PROJECT DESCRIPTION:  
**LOT 33AE BROOKSHIRE MEADOWS - SR**  
BUILDER:  
**IDK HOMES**

**A-1**  
SHEET # 1 OF 7  
SCALE: AS NOTED  
DATE PRINTED: 2/6/2025

**FRONT ELEVATION**  
SCALE 1/4" = 1'-0"

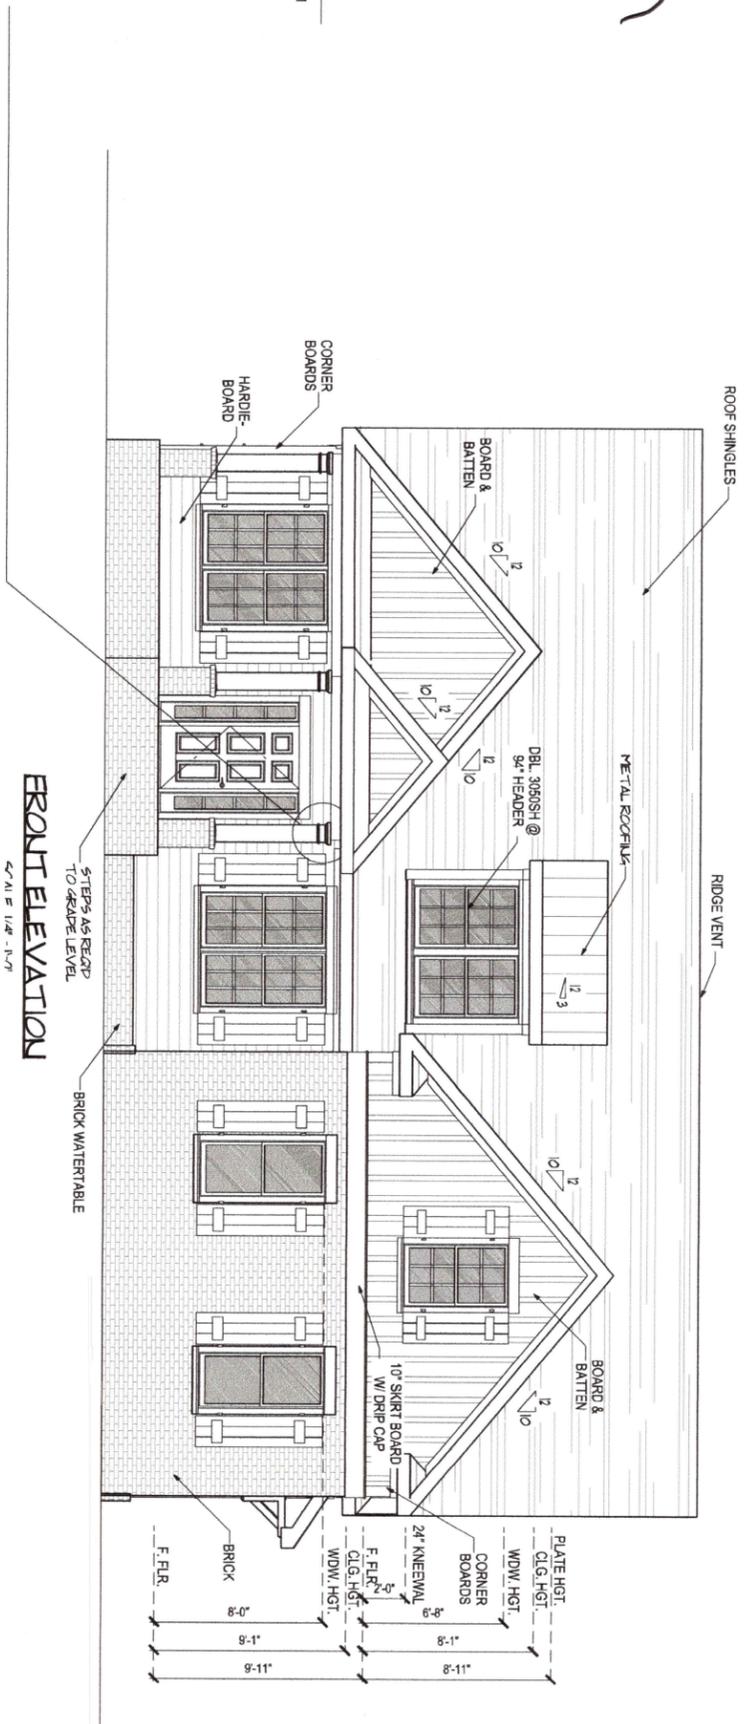
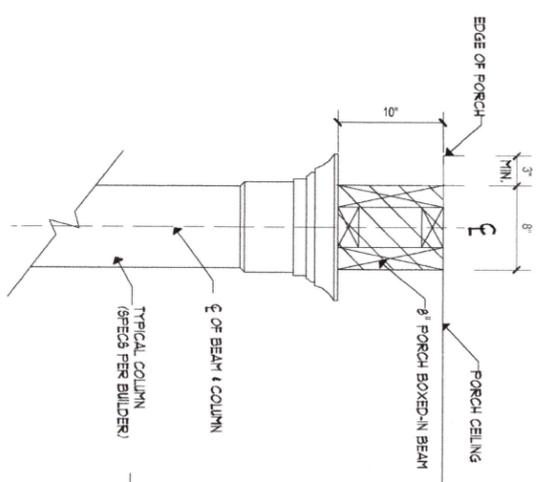
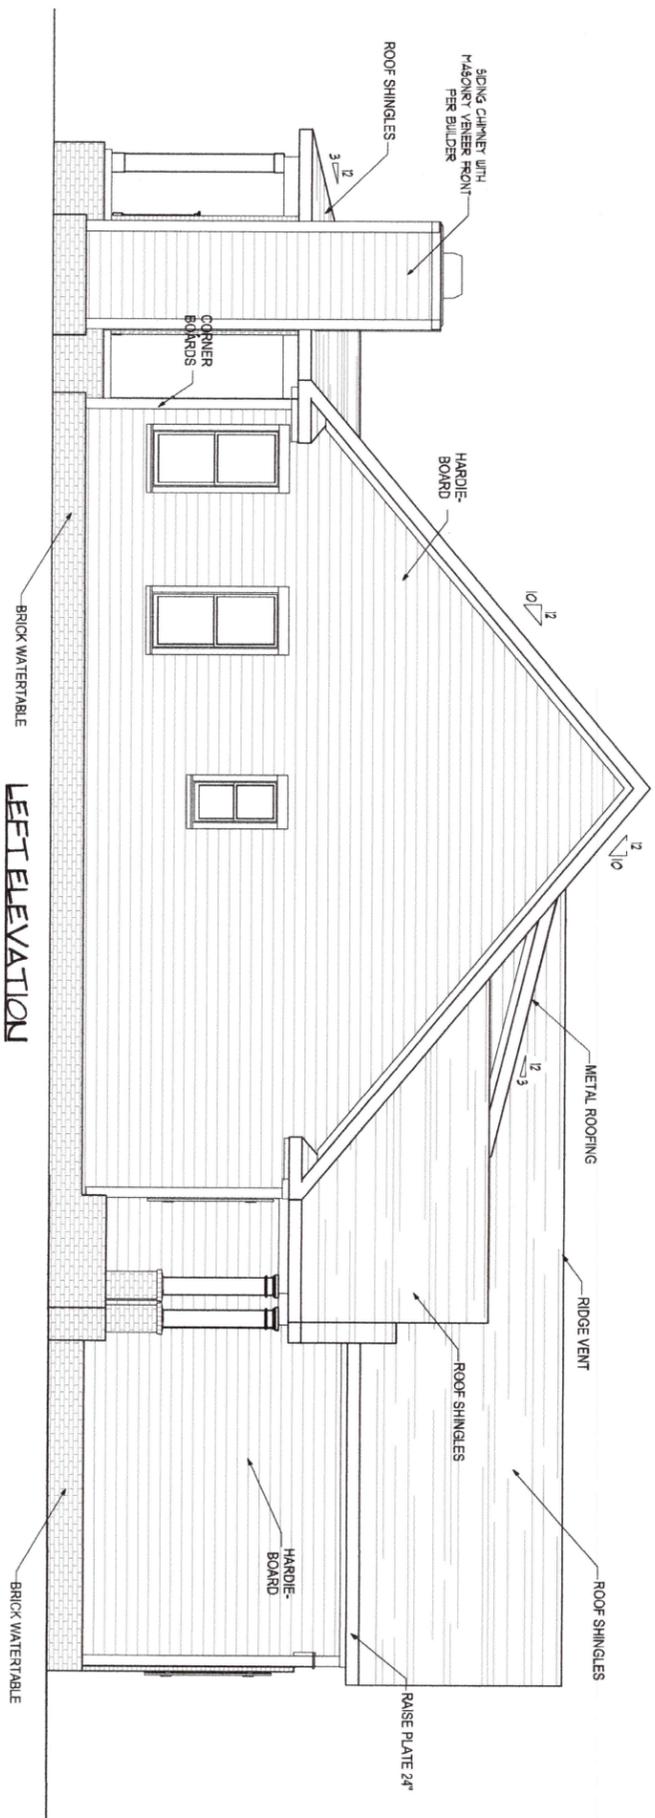
*NO  
Fireplace on  
Outside porch*
